Owner review, 2021-12-16, Approved with Comments
MacGregor reply on 2021-12-16
Owner reply on 2021-12-20 (see Comments List)

ISSUED FOR APPROVAL

FRAME
A-FRAME
DIMENSION SKETCH

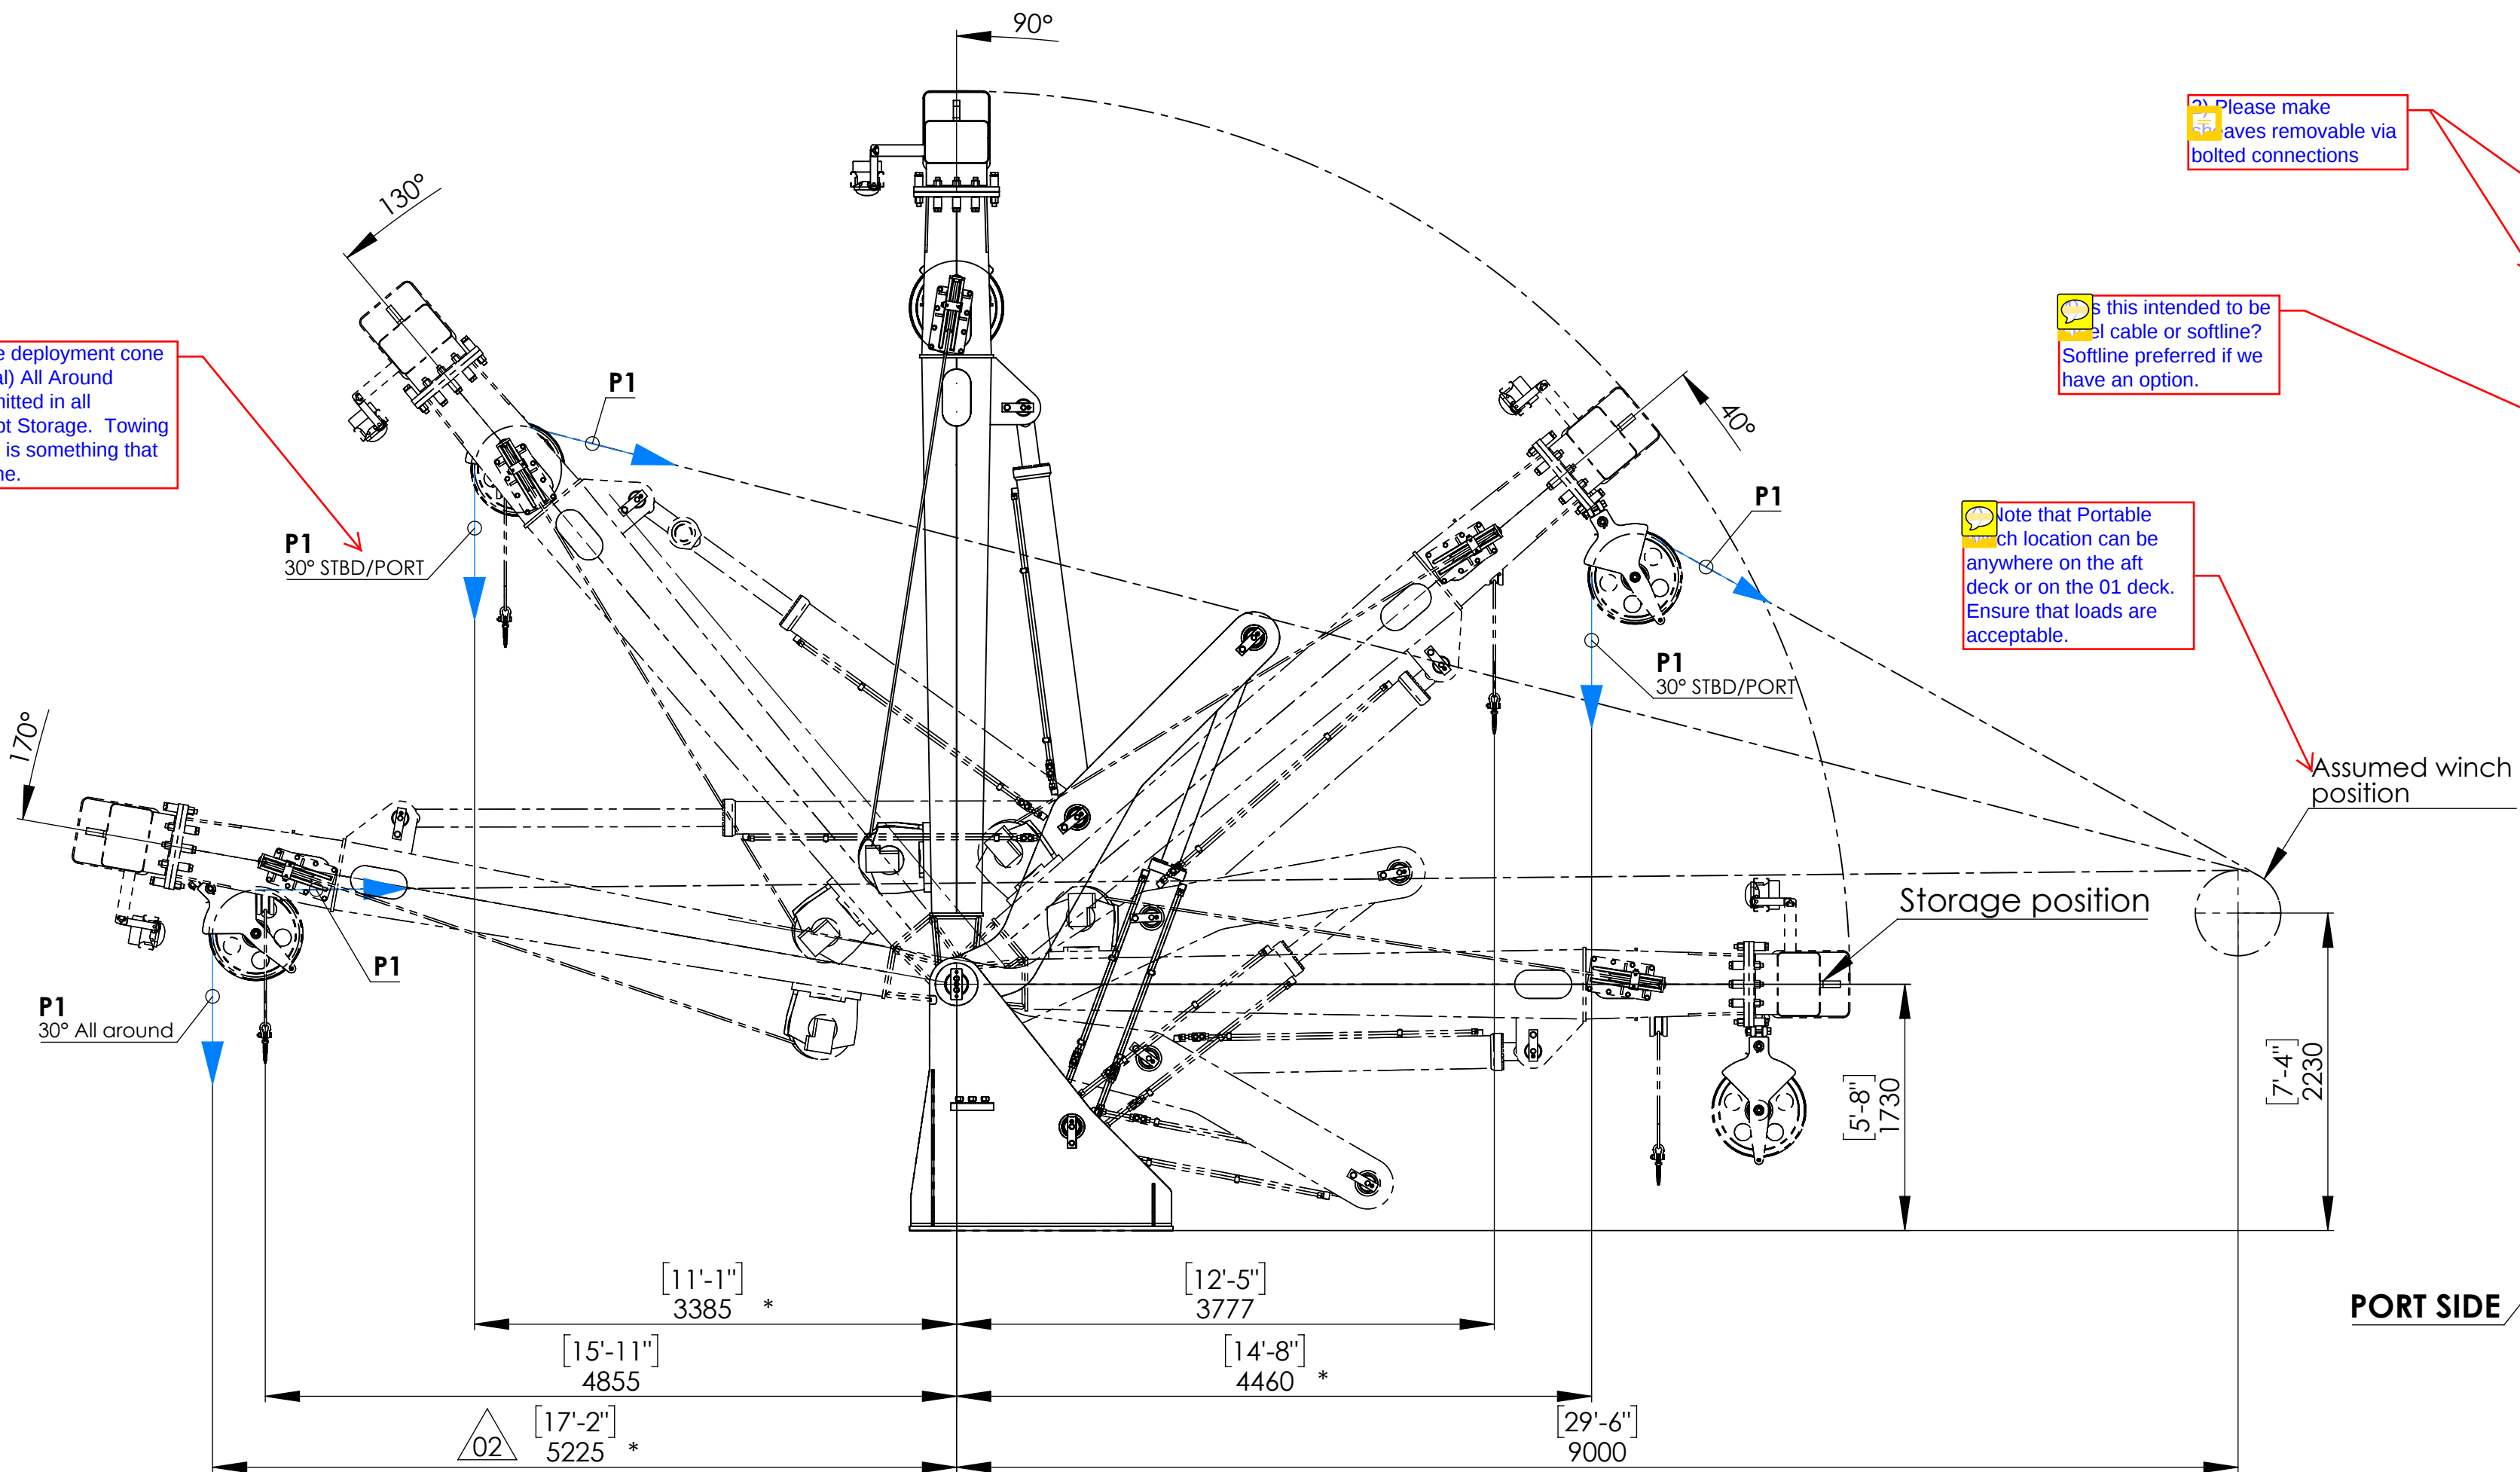
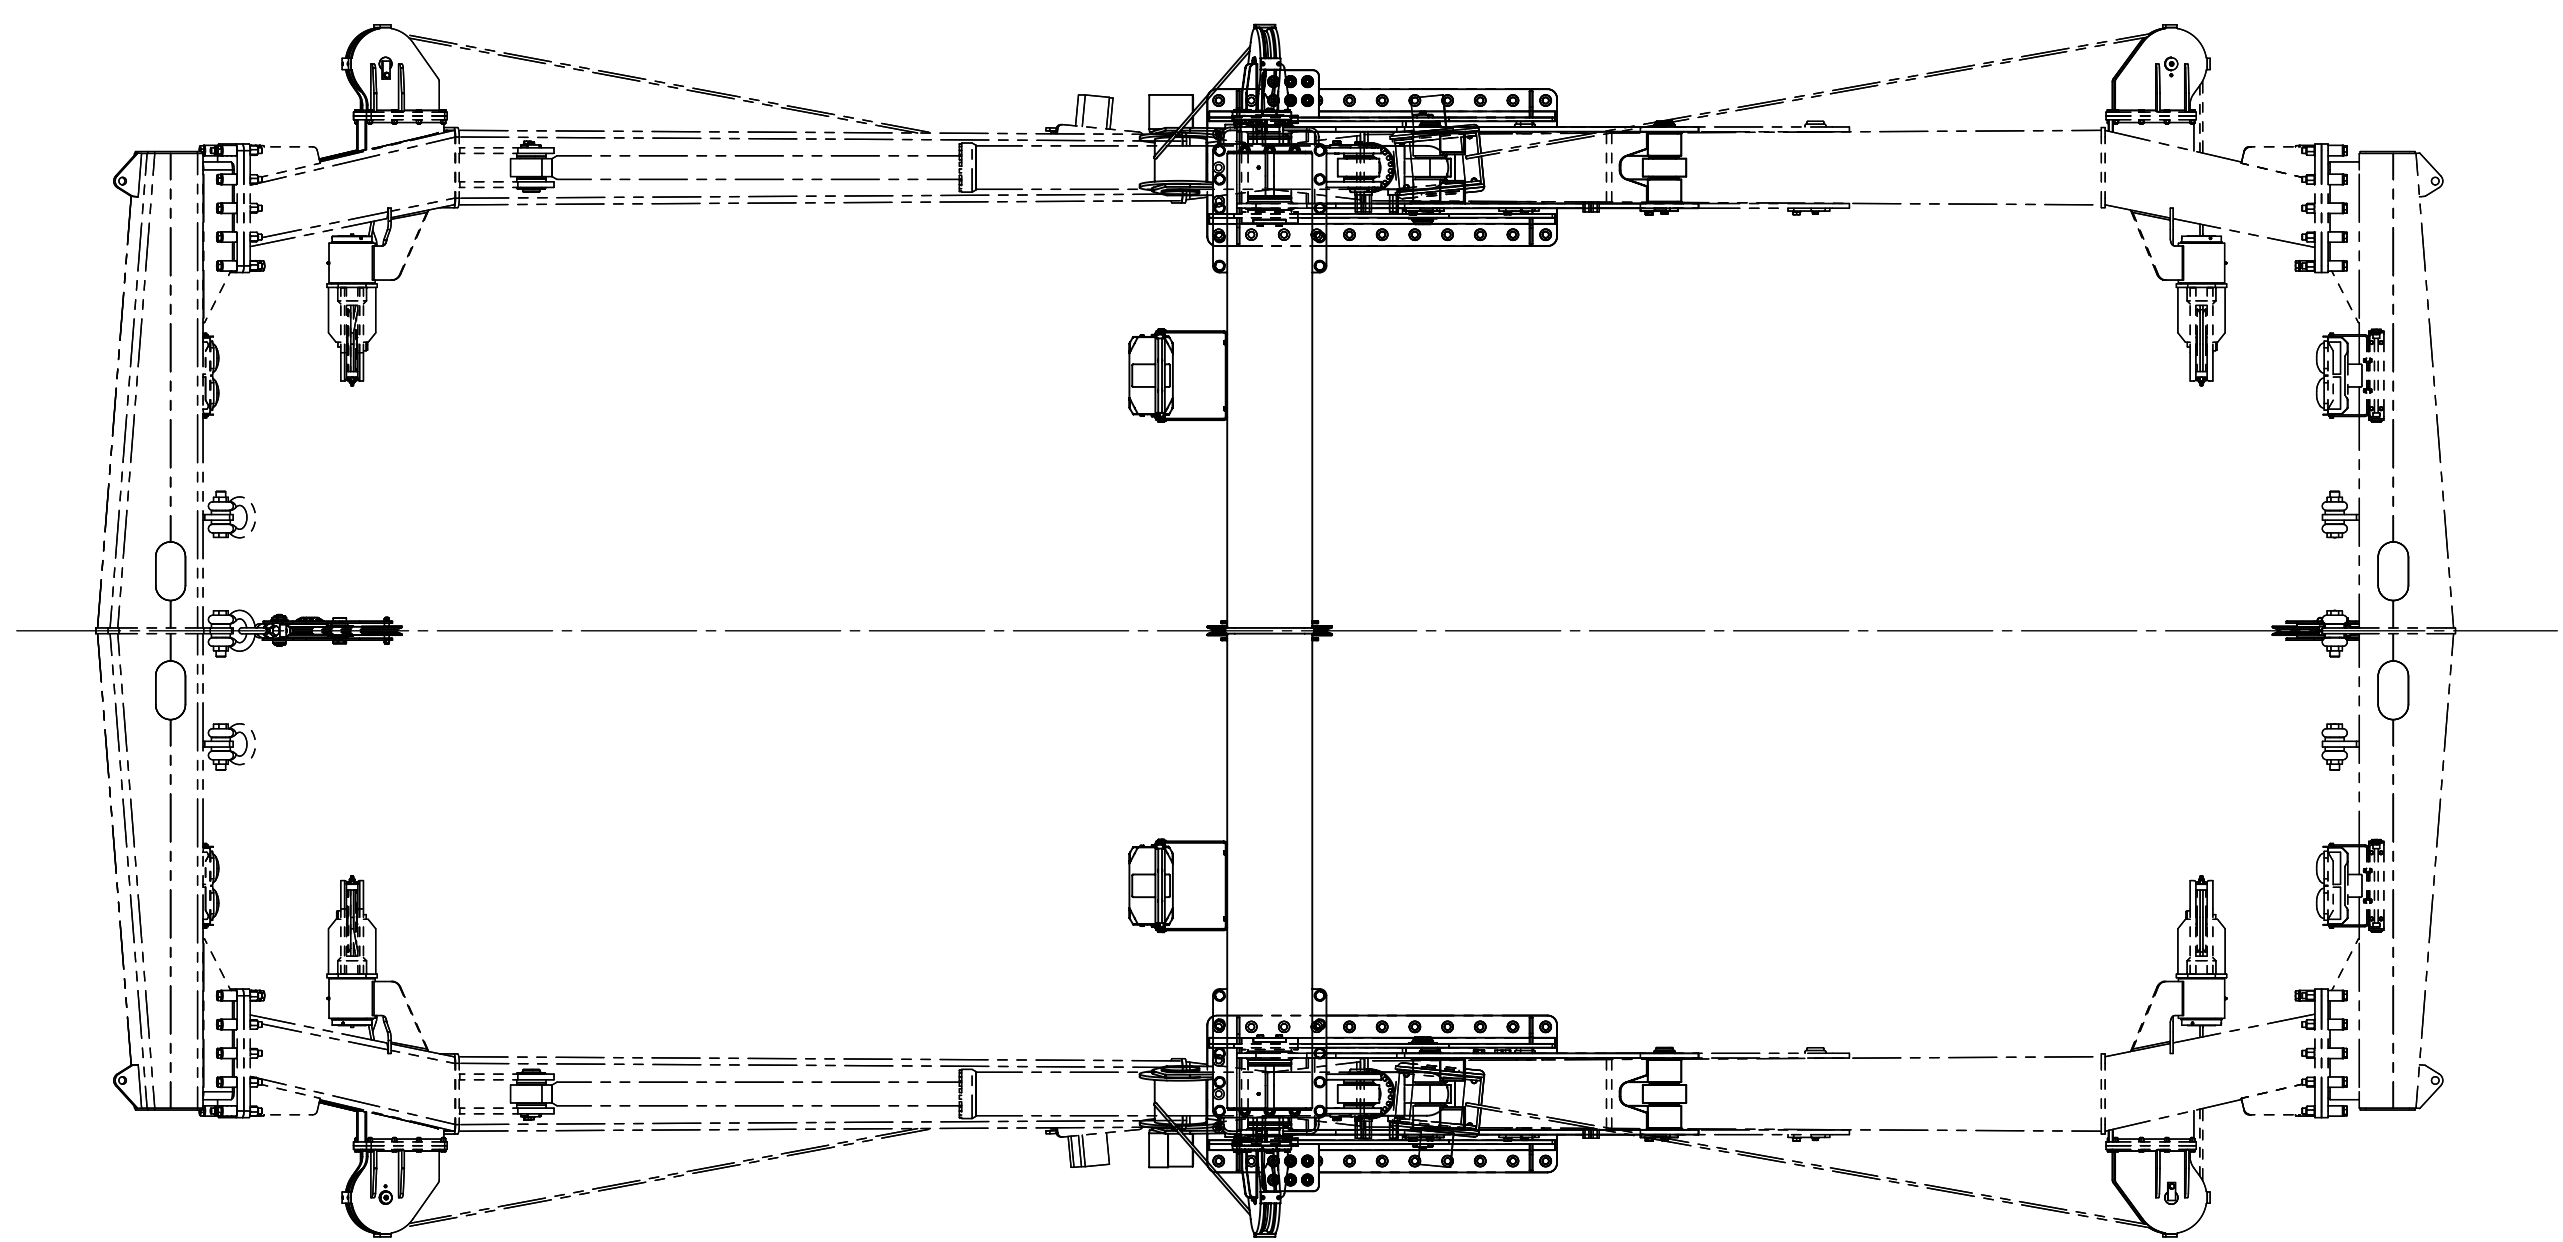
17-30 degree deployment cone (degree total) All Around should be permitted in all positions except Storage. Towing off the A-frame is something that will also be done.

2) Please make padeyes removable via bolted connections

3) Is this intended to be a cable or softline? Softline preferred if we have an option.

4) Note that Portable winch location can be anywhere on the aft deck or on the 01 deck. Ensure that loads are acceptable.

1) Add additional padeyes port and starboard; can be lower load rating if needed.

3) Floodlights shall freely rotate to always point down

6) A-frame is intended to be used for emergency recovery of ROV. Please confirm loads will be acceptable)

8) please report consistent units (kN or tonne).
